BID ADDENDUM NO. 1
TO
CONTRACT DOCUMENTS
AND
TECHNICAL SPECIFICATIONS
FOR
POOL LOCKER ROOM RENOVATIONS
AT
HOMMOCKS MIDDLE SCHOOL
NYSED #66-07-01-03-0-011-031

Mamaroneck Union Free School District
1000 West Boston Post Road
Mamaroneck, NY 10543

LAN Job #4.1092.87
September 13, 2024

Job No. 4.1092.87
File No. 4109287E501
E5.01

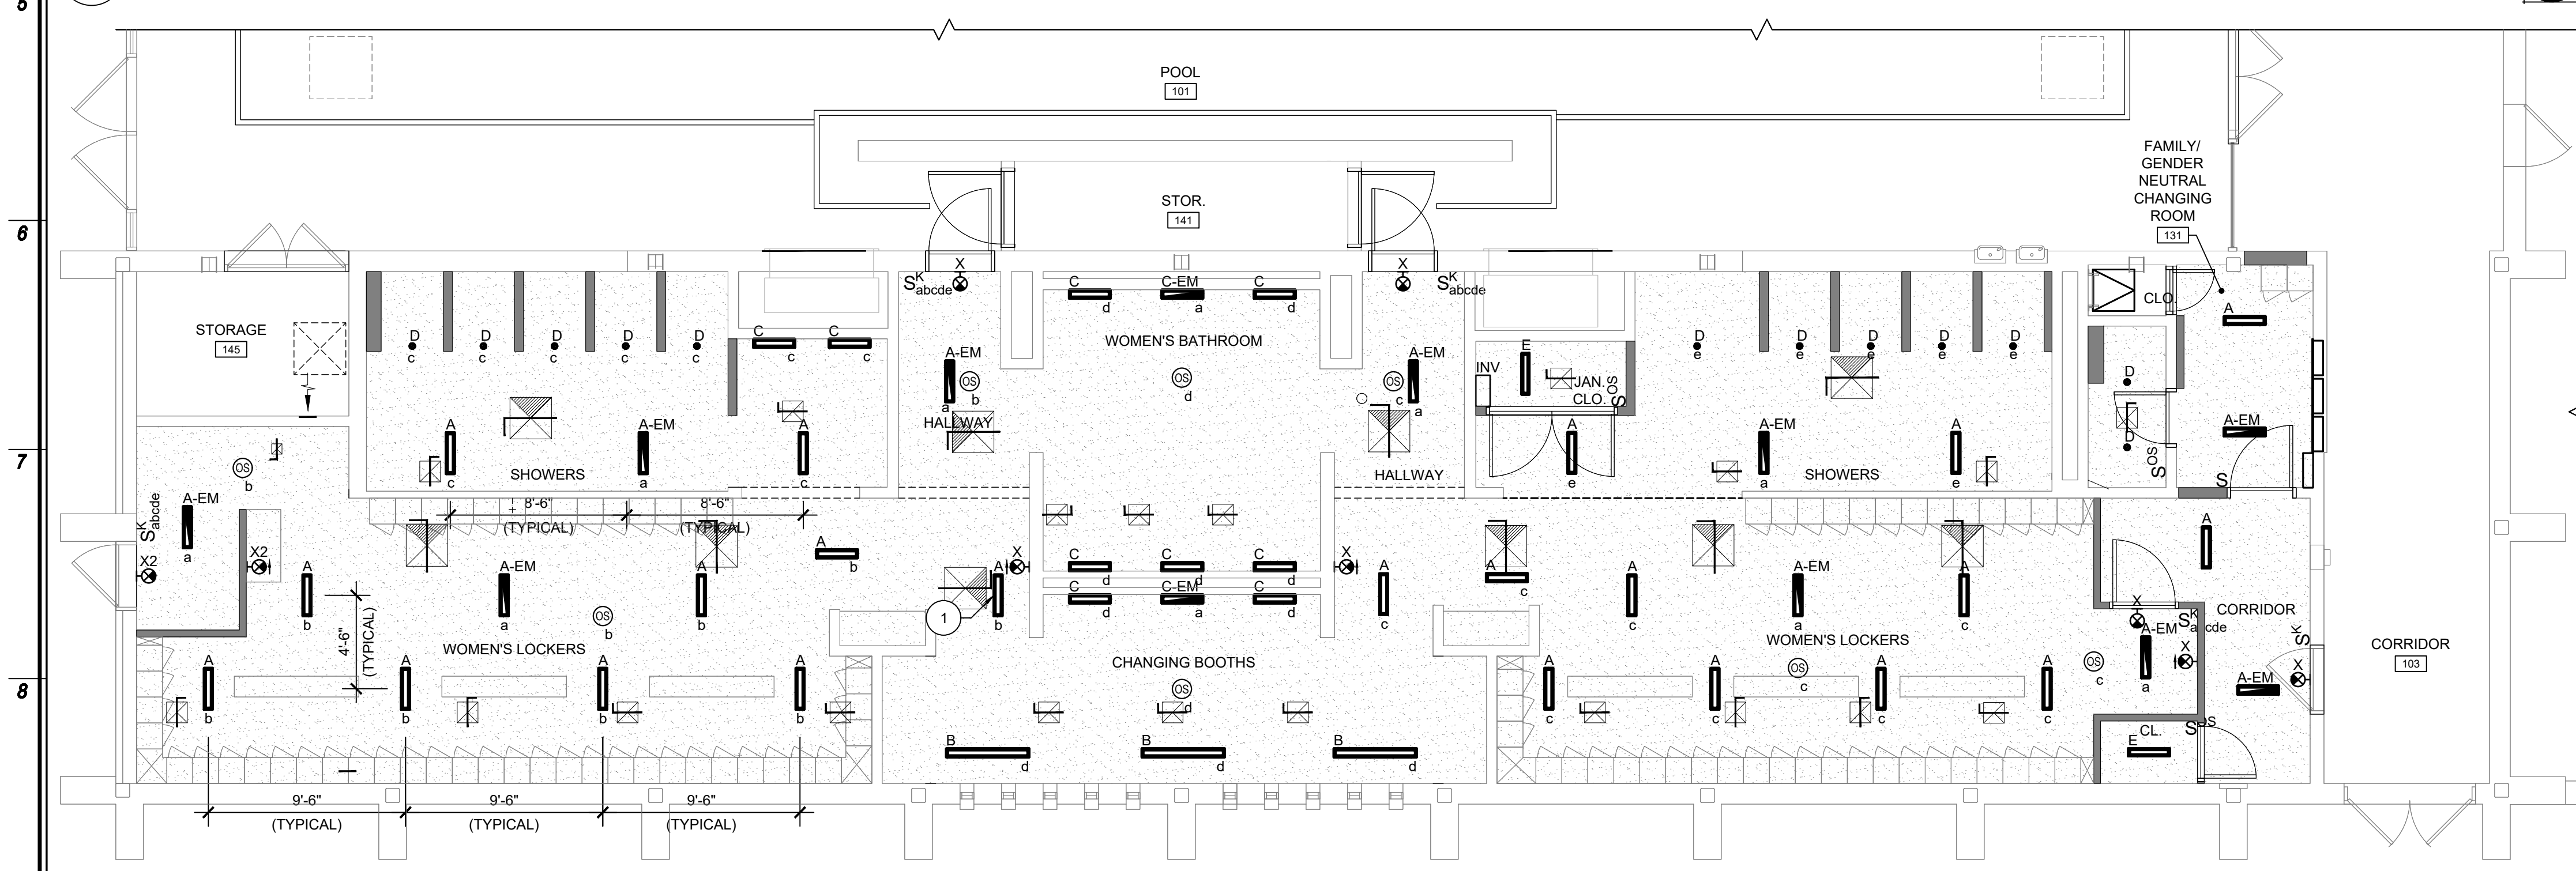
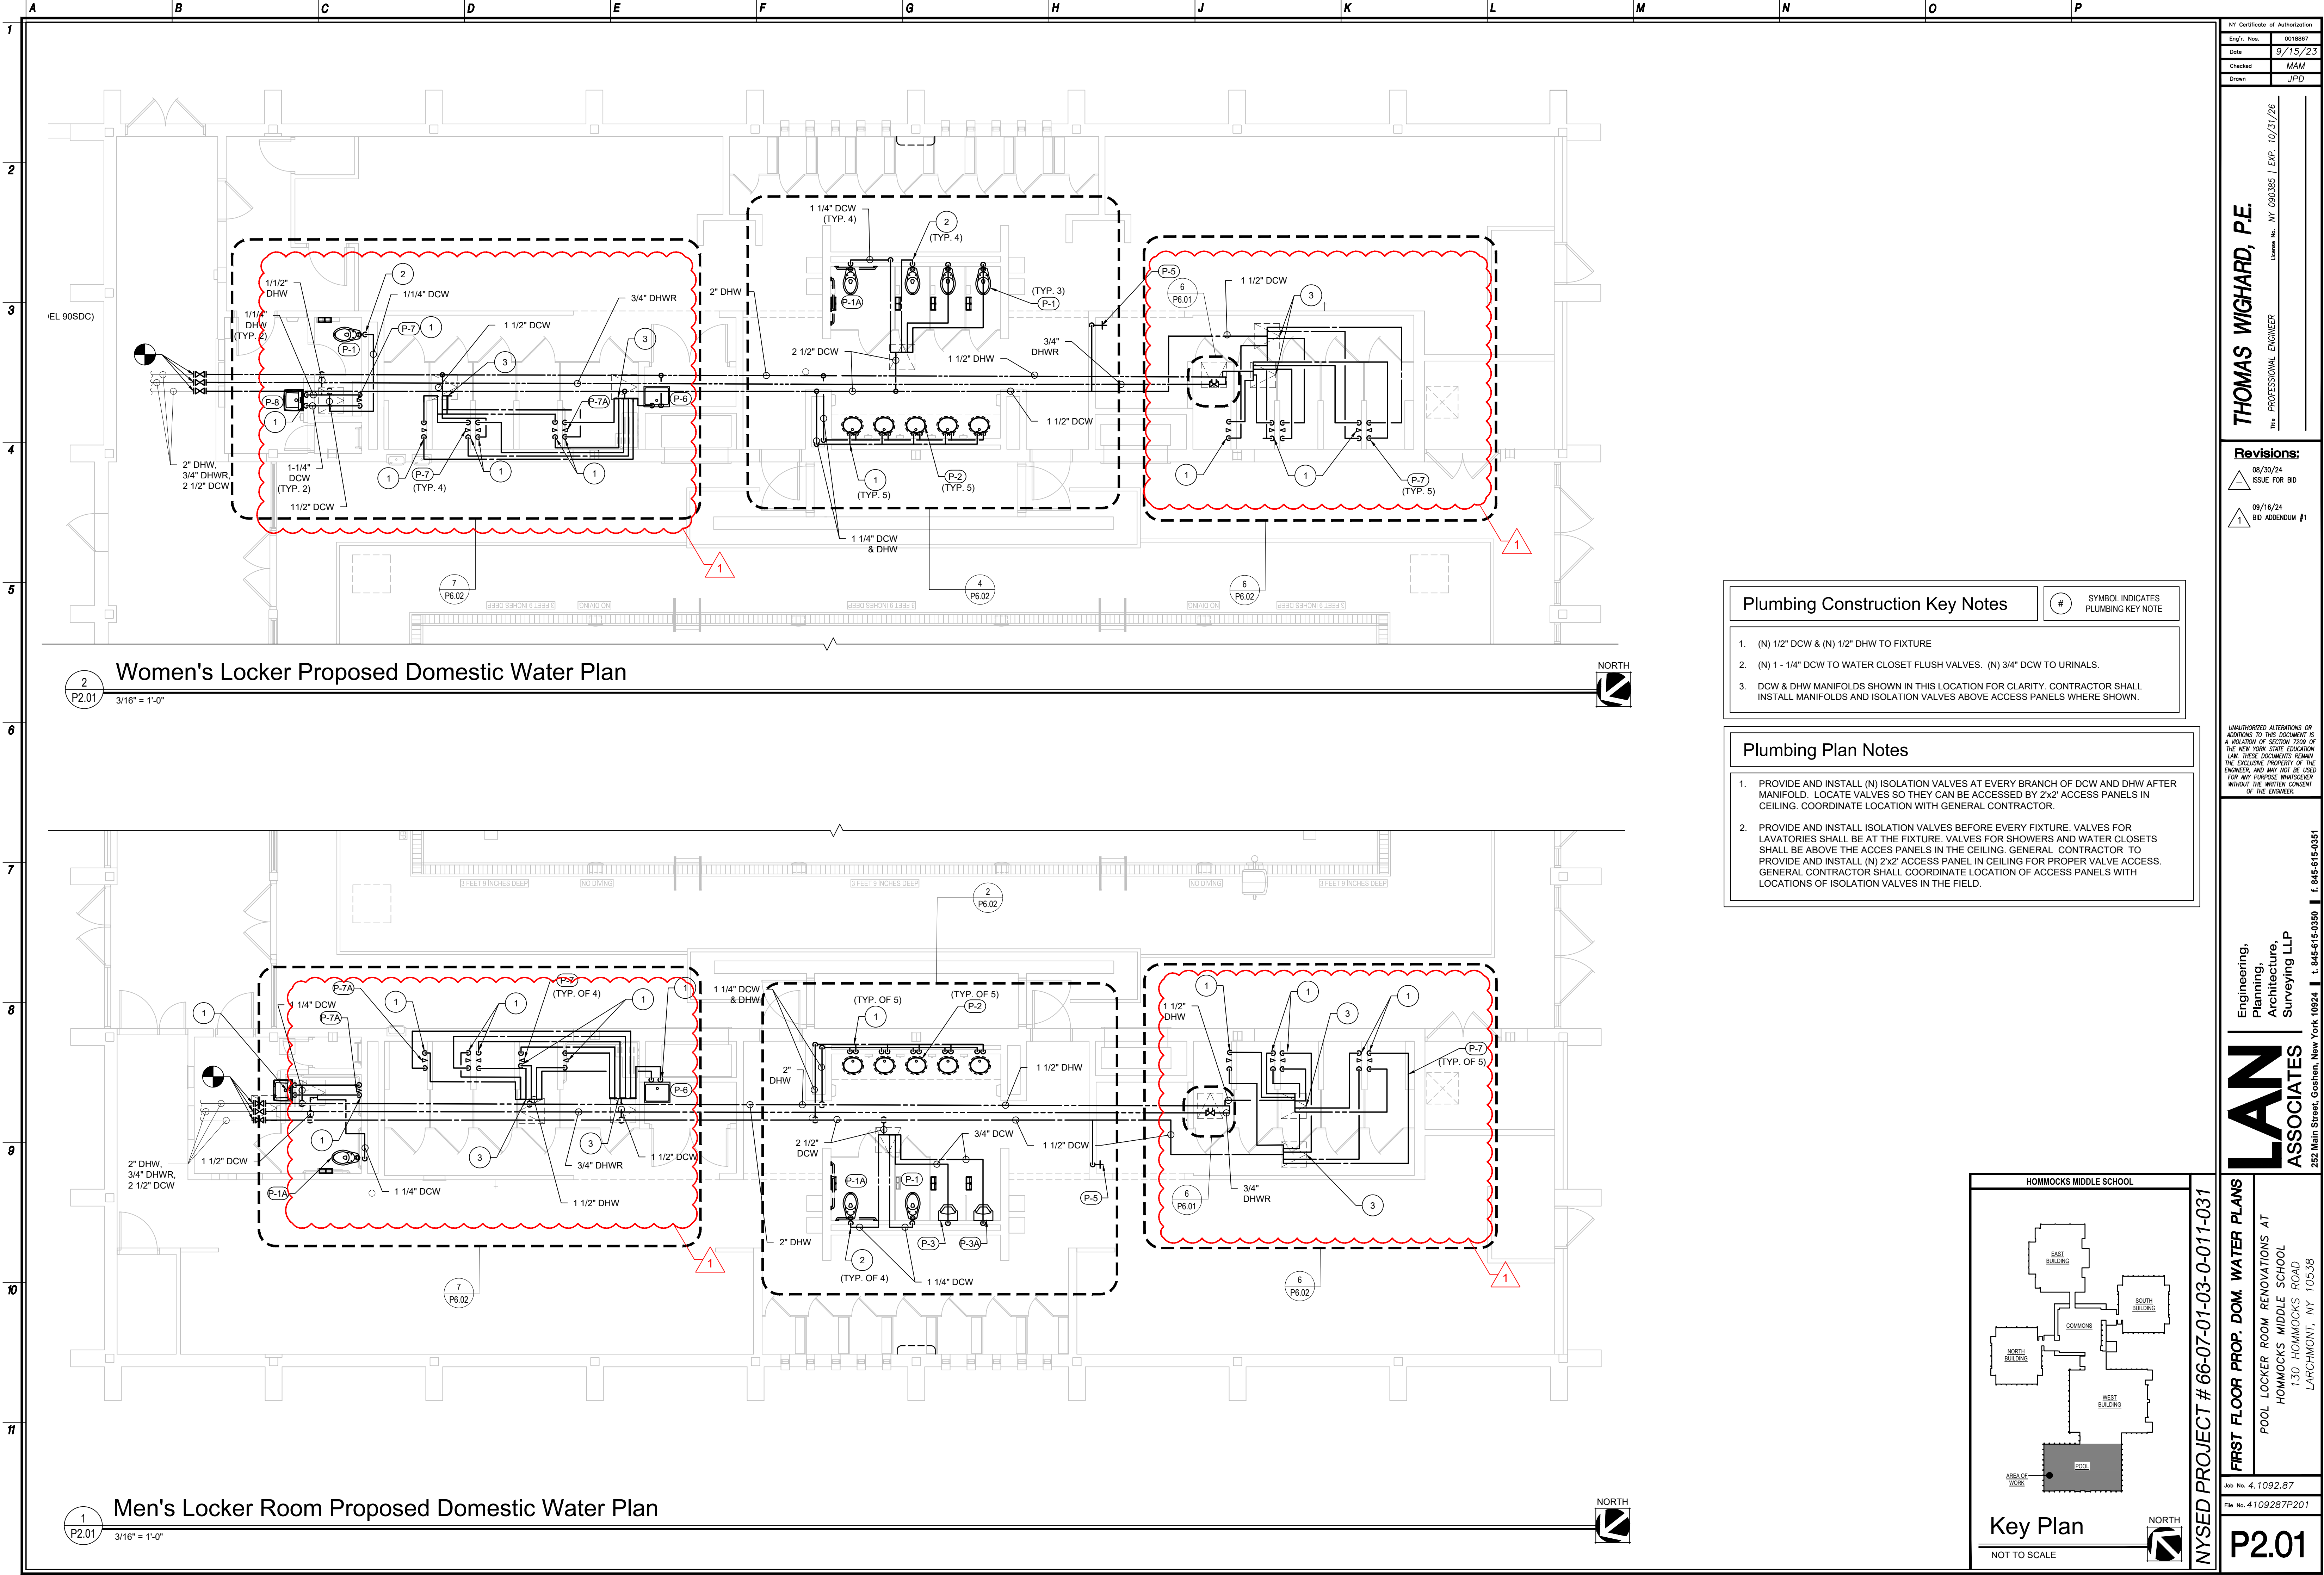
No.	Comment/Response
1	<p>Comment: Please clarify hardware sets. No information on hardware sets in specs or drawings.</p> <p>Response: Addendum #2, which will be issued in the following week, will include door hardware.</p>
2	<p>Comment: Please provide schools fire alarm vendor information.</p> <p>Response: Open Systems Metro (914) 241-0057</p>
3	<p>Comment: Drawing E5.01 indicates ceiling Occupancy sensors, wall Occupancy sensors, wall mounted Switch-Occupancy sensors etc. and a Detail #3 Lighting Control Riser provides added details for the "lighting control system", however, no manufacturer or catalog numbers are provided for any of these devices and there is no Lighting Control section in Division #26 of the Specifications that addresses these devices. Please provide information/specifications for the same.</p> <p>Response: The system is based upon Hubble NX as the basis of the design. Refer to revised drawing E5.01.</p>

4	<p>Comment: On Drawing E5.01 there are (3) Type E fixtures indicated in Janitor Closets but no such Type is listed in the Light Fixture Schedule on that Drawing; please provide a manufacturer and catalog number for these fixtures.</p>

- Response: Refer to revised E5.01 drawing.
- 5 Comment: On Drawing E5.01 there are S^K Switch locations with abcde; is this meant to indicate (5) S^K Switches in a common faceplate?

- Response: No. It's a single switch that shall be programmed to control the zones listed. Where there are multiple switches, they will be indicated with multiple "S's".
